Advisory Committee Report

**Victorian Transport Projects Integrated Development
Opportunities Standing Advisory Committee - Ormond
Station**

31 March 2017

PART 1: Building Envelope Plan

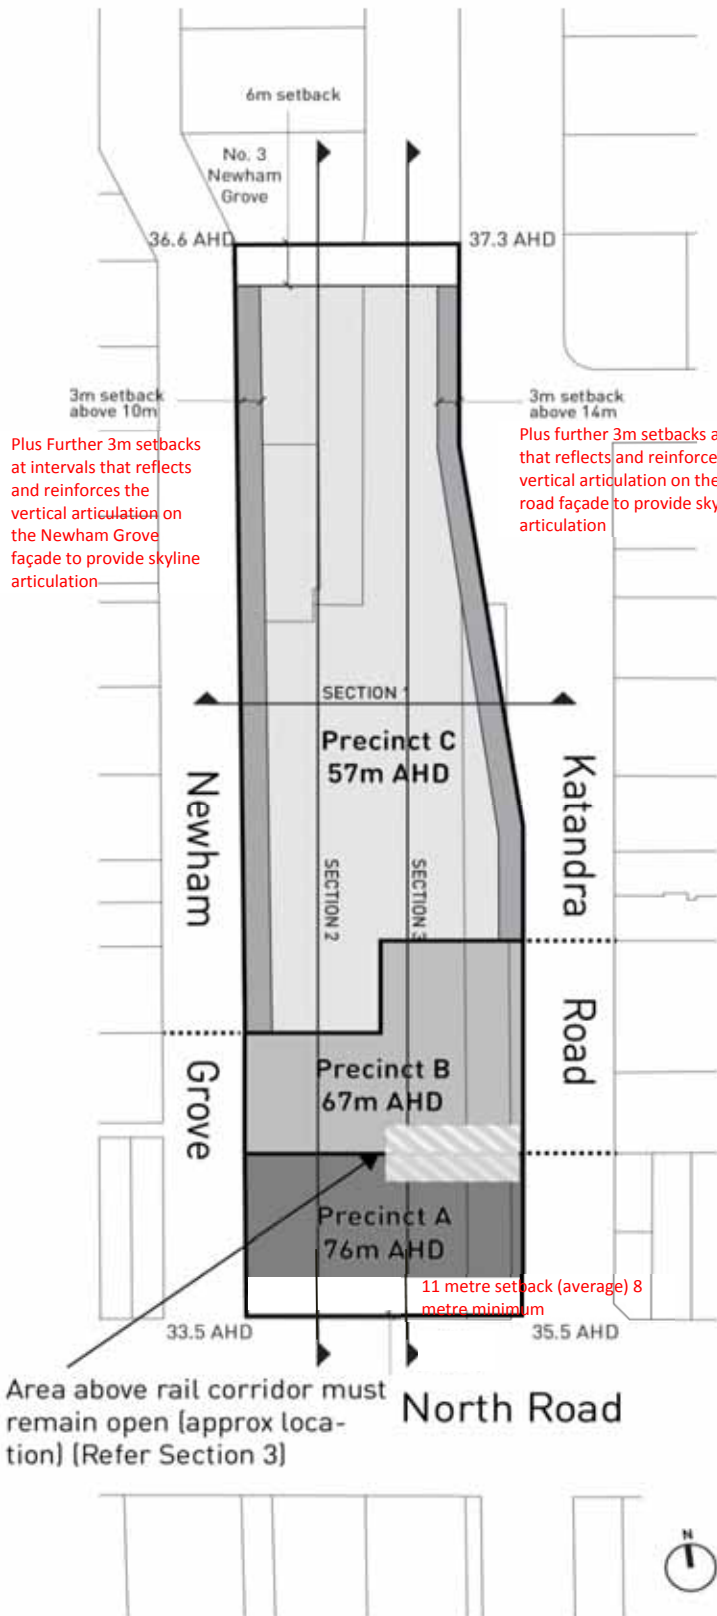
In relation to the key question of how high should the buildings be, the Committee considers that for Precinct A, the answer fits within a range of between 6 and 12-13 storeys. Below six storeys, its landmark presence would be lost as the surrounding area on North Road develops. Furthermore, such a development might arguably fail to fulfil the potential of the site. Over 12-13 storeys, serious objective problems would arise in relation to overshadowing. In establishing the optimum height, the Committee considers the Building Envelope Plan as exhibited is a blunt weapon to ensure the building is of an adequate standard of design to justify its departure from the surrounding area. This is because the

mass allowed by the Building Envelope Plan would amplify the negative impacts of the height, giving the street frontage a potentially monolithic presentation to surrounding streets and North Road that is at odds with the fine grained character of these areas. The Committee agrees with the contention that a departure from the existing character can only be justified to create a landmark and reinforce the site's civic function. The Committee further notes that balancing the need to maximise value capture with the sensitivities of the surrounding character is not simply a matter of picking a number of storeys somewhere in the middle of this 6 to 13 storey range.

Note: Above street wall height, building should be setback at least 3m from the facade below.

*Indicative equivalent height in storeys.
** No more than 50% of the area of Precinct A to exceed 71 metres (10 storeys).

PART 2: Site Access Plan

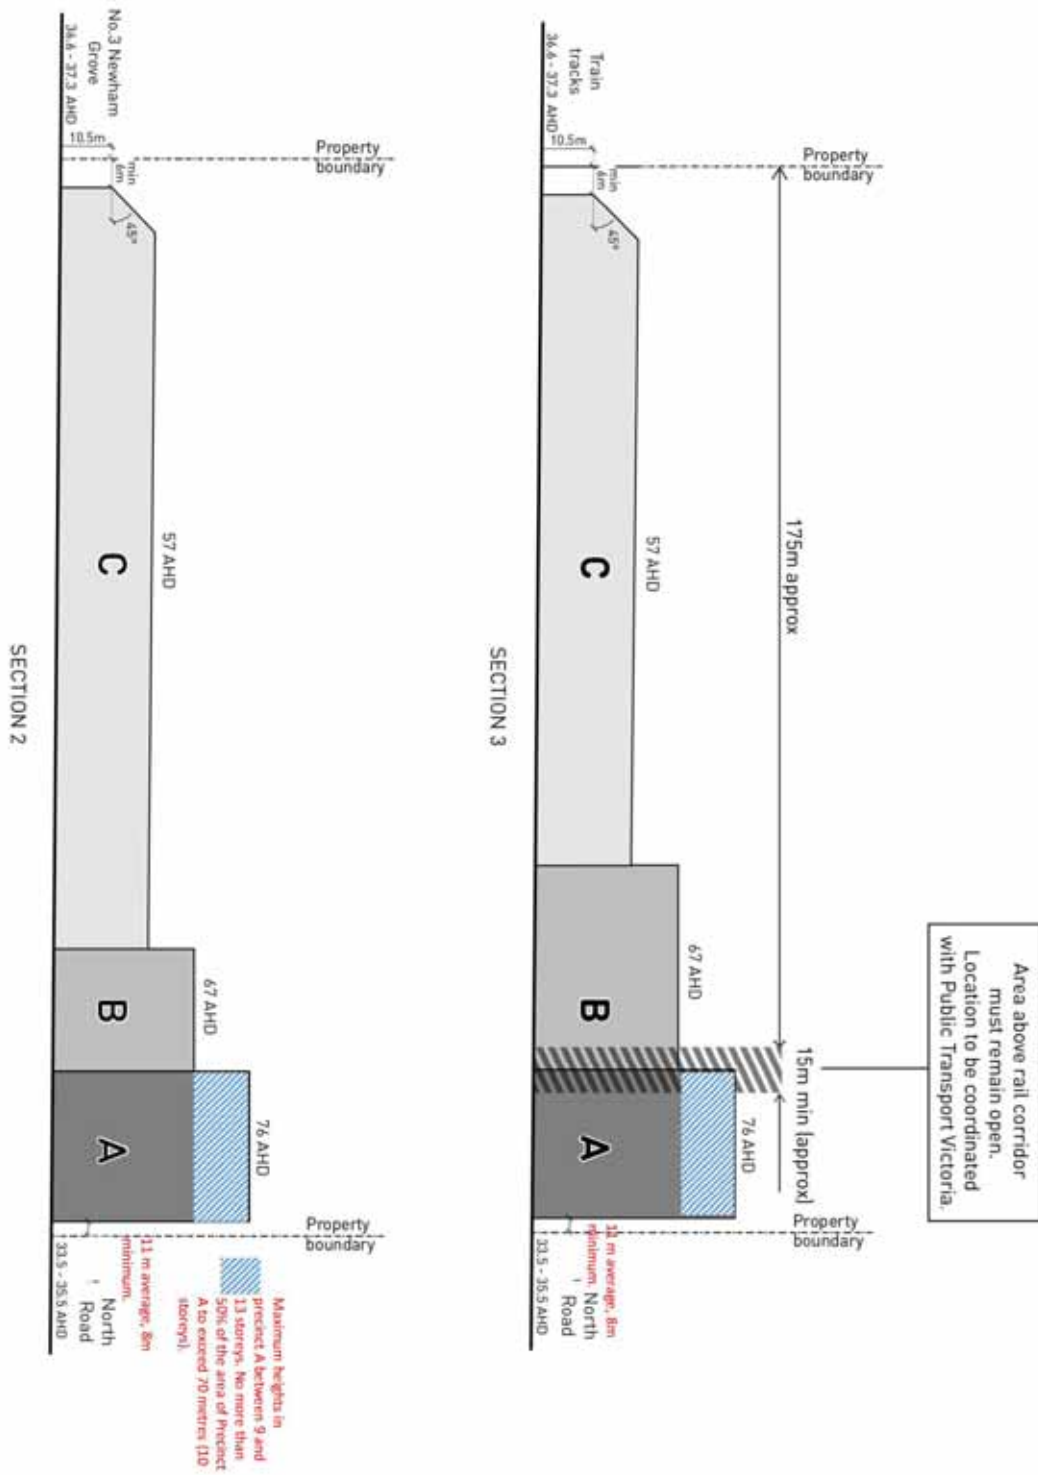
Council submitted that the Site Access Plan appeared not to encourage pedestrian movement and circulation through the site, other than the northern end. This may result in any development turning its back on Katandra Road resulting in poor integration with the surrounding area. The Council submitted that the Site Access Plan should be modified to show the location of the Katandra Road shared path.

Note: Committee changes as proposed in red

PART 3: Public Realm Improvement Plan

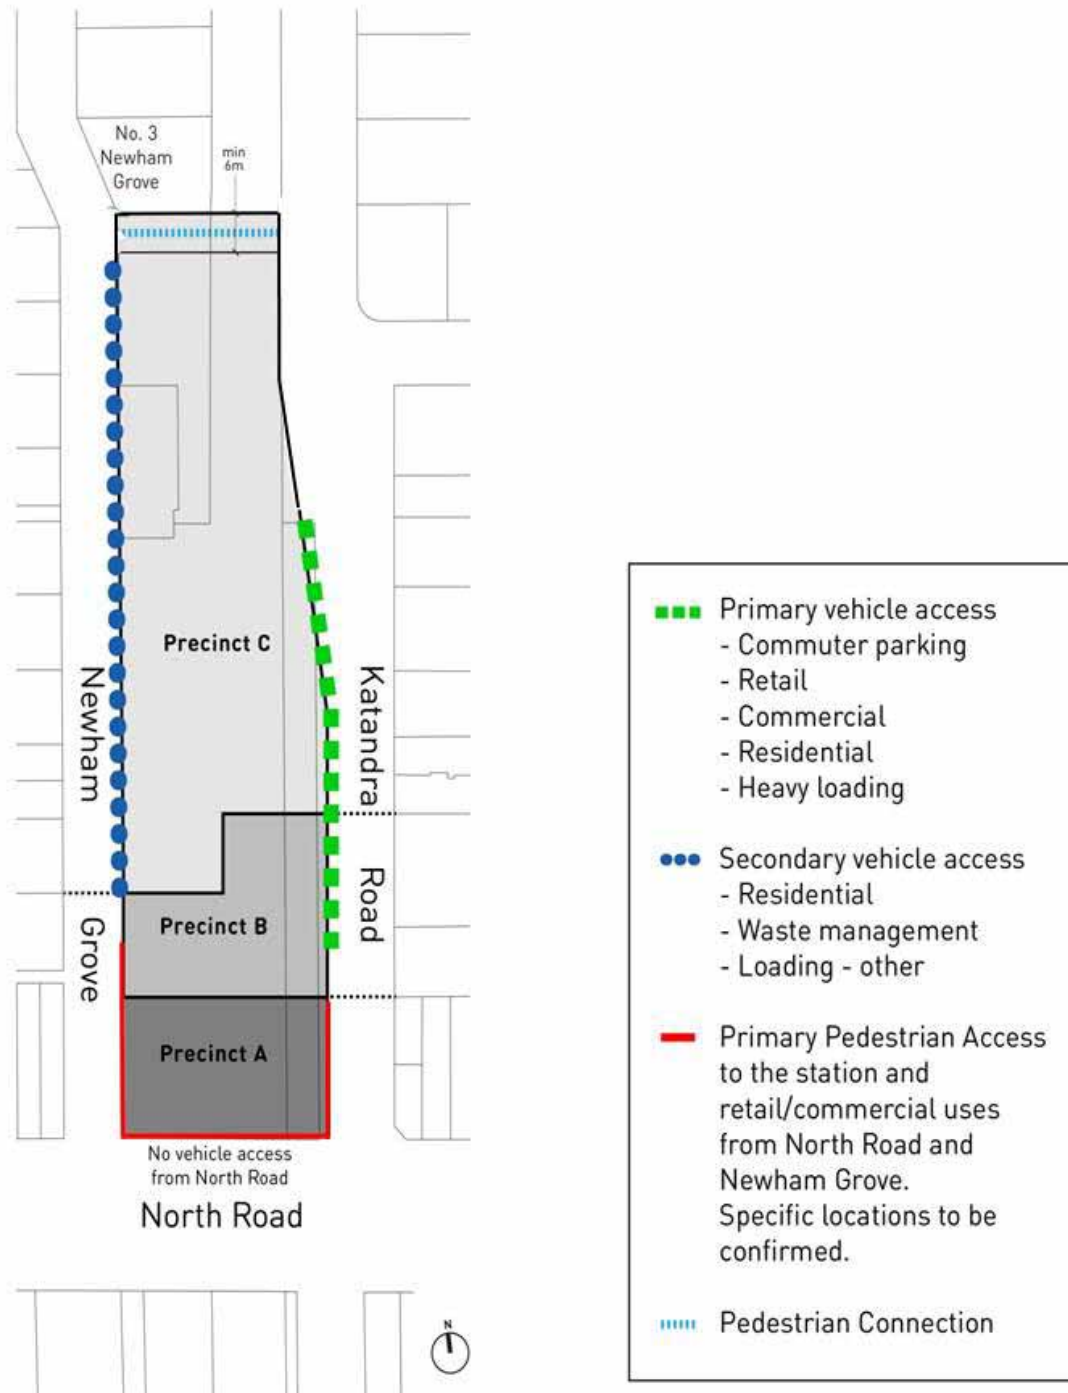
VicTrack acknowledged the *“general agreement that the southwest corner of the site constitutes the most appropriate location for a public plaza”* and made provision for such a plaza in the Public Realm Improvement Plan. The Committee received diverse advice about the extent of any setback from the building line to accommodate this plaza. VicTrack contended that a setback of 8 metres as advised by Mr Czarny would be a poor urban design outcome, and that:

The Committee agrees with the evidence of Mr Milner, Mr Czarny, Mr Sheppard and Ms Heggen that this development should reflect the site's civic function through the provision of a plaza directly adjoining the station entrance, and a distinctive design response to the adjoining building that provides a landmark. It further agrees with Mr Sheppard that the interface condition between the plaza and the building will be an important consideration. The Committee contends that if this space is to maximise its contribution to the community, and the character and identity of the Ormond Activity Centre, this interface will need to accommodate uses that activate this space. It will need to be finished to a high standard of design that considers its location against North Road, its southerly aspect and location against a building of significant height.

- The development must include a landscaped public plaza generally open to sky with a canopy required to provide a forecourt for station entry across the front of the development of average 11 metres and a minimum of 8 metres in depth behind the building line. This will allow it to be read as a distinctive and defined space that is capable of accommodating the peaks of pedestrian movements through it as buses and trains arrive or depart as well as facilitating a range of other functions that would be expected at a community hub. A canopy may intrude into this setback to no greater extent than the existing canopy.

- The public plaza should incorporate a co-ordinated suite of landscaping and street furniture that provides a minor landmark at eye level, provide shade and shelter, and facilitate activation.
